## GRAND NATIONAL RESTAURANTS & RETAIL PHASE 1

**Applicant's Request:** The applicant is requesting Specific Parcel Master Plan (SPMP) approval of ±52,870 sq. ft. of restaurant and retail uses, as the initial phase of the Grand National development. The property is located in the N.

**Staff Recommendation:** Approval of the Specific Parcel Master Plan, per the conditions in the staff report.

# PROPOSED PHASE 1 LANDSCAPE PLAN

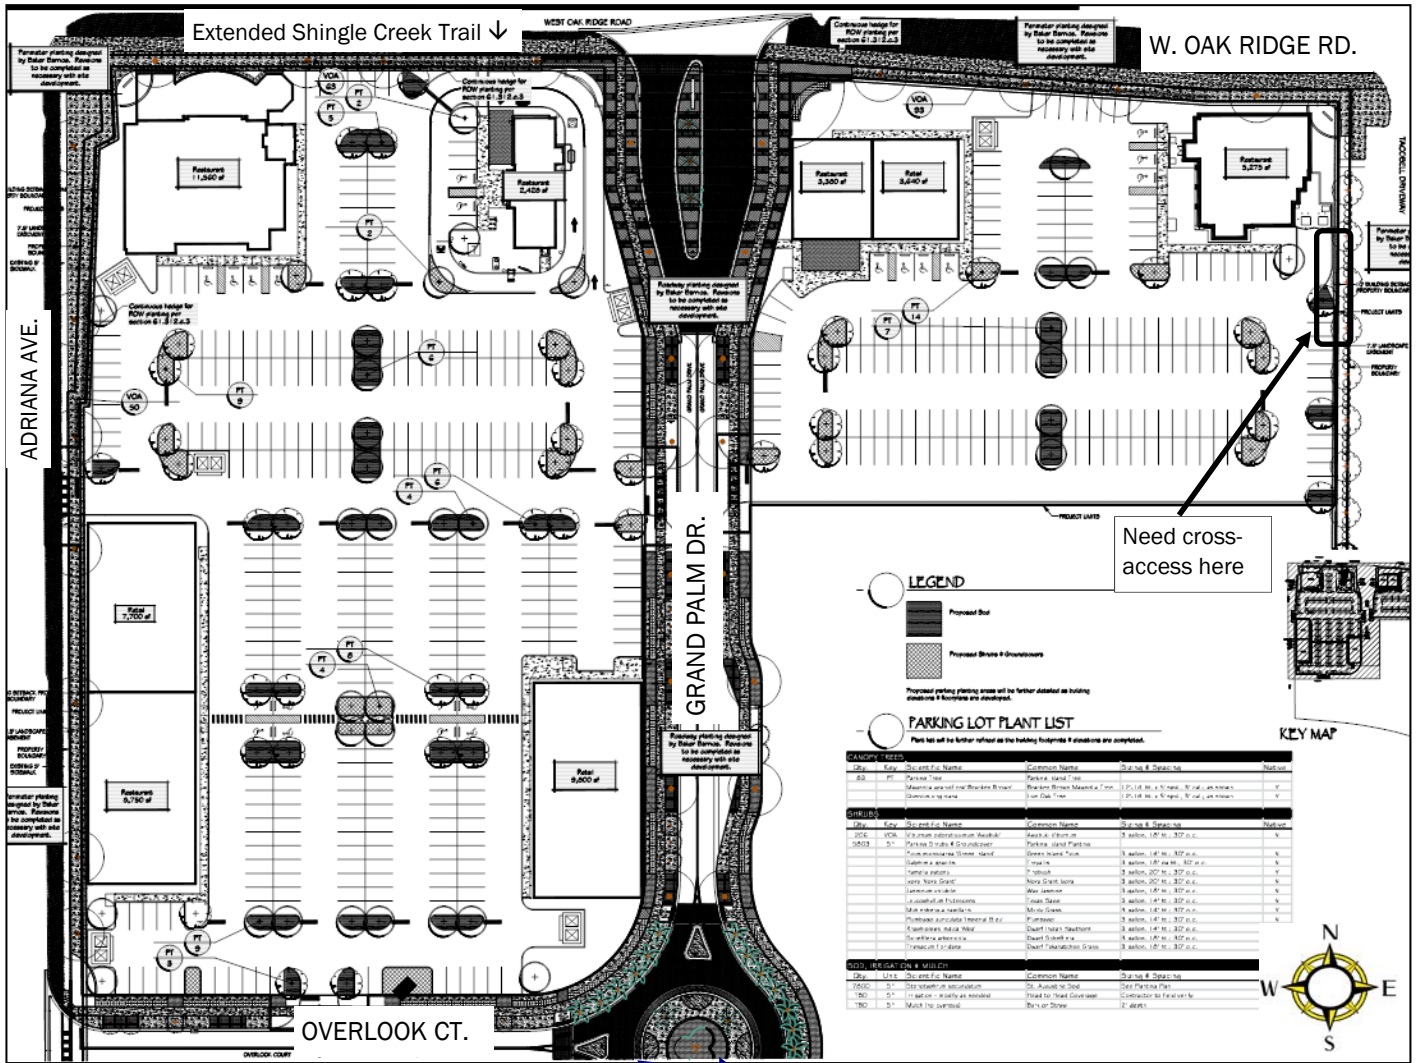
16. One of the objectives of the North International Dr. Special Plan is to preserve, enhance and promote the positive aspects of the district. A more enhanced, more intensive Tropical landscape with palm trees is required (the proposed plantings do not meet the lush tropical landscape as desired). Different size plants must be mixed and matched to create textured layers. To make the space more visually interesting, various shades of green must be used to create texture by mixing leaves in different sizes and shapes, such as low-lying, fernlike palms with the large broad leaves of philodendrons. Flowers are not the only source of color in a tropical landscape. Foliage provides an array of hues and leaf shapes, and adds variety in a more permeate form.

⑧ **DUMPSTER ENCLOSURE - PLAN**  
SCALE: 1/4" = 1'-0"

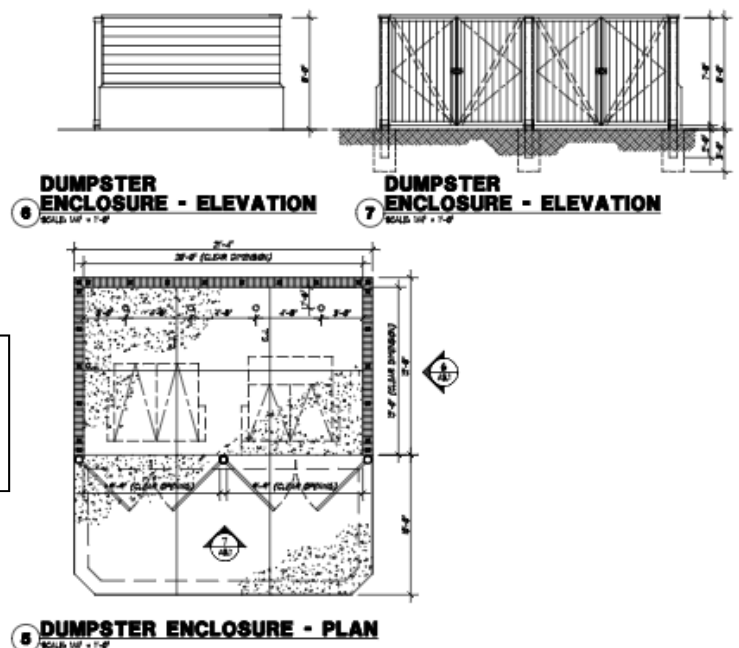
19. All dumpsters and trash compactors must be screened with solid walls to match the principal structure. Decorative gates must be installed to coordinate with the principal structure. Landscape screening including low hedge and groundcover is required to soften the view from the public R-O-W.
